# Access Compliance Report

## Public Rights-of-Way

### (Curb Ramps)

Intersection ID: 48769	Main Street: KNOTHOLE_LN	Cross Street: SONOMA_VALLEY_DR	Location: NE
ADA ID: 61F5C2ECFD2D	Ramp Type: PerpDiag	Initial Pass/Fail: Fail	Overall Compliance: No
Severity Score: 8.75			
Codes/Mitigation Info/Possible Solution		Field Measurements/Component Compliance

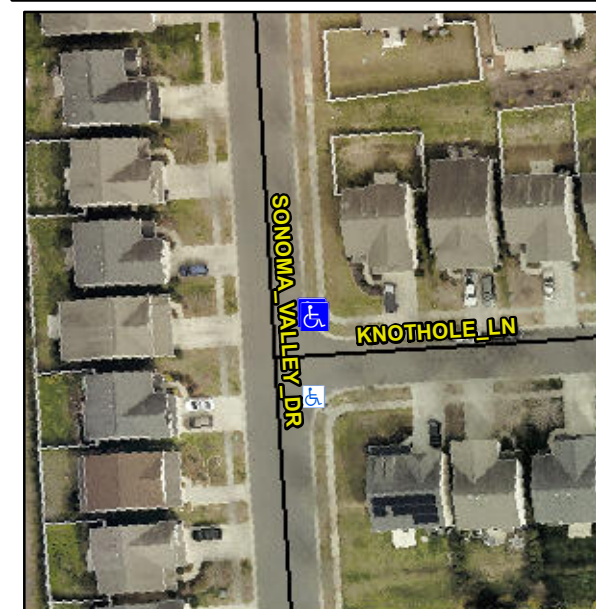
**Not Found, R304.5.1**

Compliance	Description	Data	Compliance	Description	Data
N/A	Ramp Length (in)	69.0	Yes	Ramp Slope (%)	6.0
No	Ramp Width (in)	47.5	Yes	Ramp XSlope (%)	0.2
N/A	Flare Type LT	N/A	N/A	Flare Type RT	N/A
N/A	Flare Slope LT (%)	N/A	N/A	Flare Slope RT (%)	N/A
N/A	Flare Traversable LT?	N/A	N/A	Flare Traversable RT?	N/A
N/A	Landing Length (in)	N/A	N/A	DWS Provided?	N/A
N/A	Landing Width (in)	N/A	N/A	DWS Contrast?	N/A
N/A	Landing Slope (%)	N/A	N/A	DWS Length (in)	N/A
N/A	Landing X Slope (%)	N/A	N/A	DWS Full Width?	N/A
N/A	Landing Curb? (Y/N)	N/A	N/A	DWS Offset (in)	N/A
N/A	Shared Landing?	N/A			
N/A	Gutter Ponding?	N/A	N/A	Gutter Slope (%)	N/A
N/A	Gutter Lip Ht (in)	N/A	N/A	Gutter X Slope (%)	N/A
N/A	Painted X Walk1?	No	N/A	Painted X Walk2?	No
	X Walk 1 Direction	To W		X Walk 2 Direction	To S
N/A	X Walk 1 Width (in)	N/A	N/A	X Walk 2 Width (in)	N/A
	X Walk 1 Slope (%)	1.8		X Walk 2 Slope (%)	2.2
	X Walk 1 X Slope (%)	1.1		X Walk 2 X Slope (%)	2.9

**Remove & Replace Curb Ramp With Two New Directional Ramps or Equivalent.**
